**HUGHES
SERVICE INFORMATION
NOTICE**

NOTICE NO. N-157

SUBJECT: REPLACEMENT OF RADIO TRANSMIT/INTERCOM TRIGGER SWITCH;
REWORK OF CYCLIC PITCH STICK GRIP ASSEMBLY (PISTOL TYPE)*

MODELS AFFECTED: All Model 269A, TH-55A, 269A-1, and 269B Helicopters
Model 269C Helicopter Serial No. 0004 thru 0739

Figure 1. Rework of cyclic pitch stick grip assembly

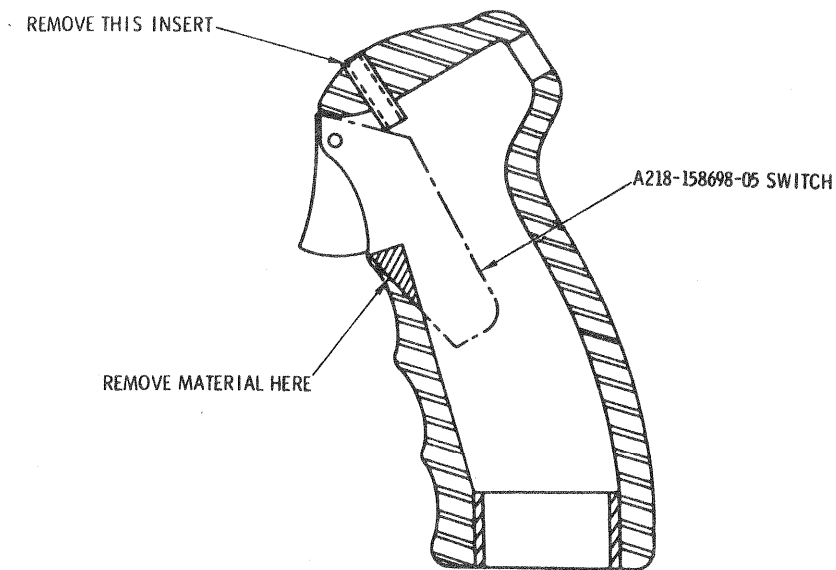
- i. Rework cyclic grip as follows: (See Figure 1)
 1. Press or pull insert from top of grip.
 2. Make template of profile of new A218-158698-05 trigger switch.
 3. Using file, blade or equivalent routing tool, remove material from lower inside edge of hole for trigger switch to permit installation of new switch. Use template to determine amount and location of material to be removed.
- j. Clean grip, wiring and switches. Reconnect (solder) all electrical wires and reinstall switches, as applicable. New trigger switch is retained by trigger pivot pin.
- k. Apply potting compound to all open screw holes and insert hole.
 1. Reinstall grip on stick tube. Using attaching strings, route grip wiring thru stick tube and reconnect at electrical plug.
- m. Check switch operation and wiring continuity.
- n. Secure wiring to stick socket with nylon strap.
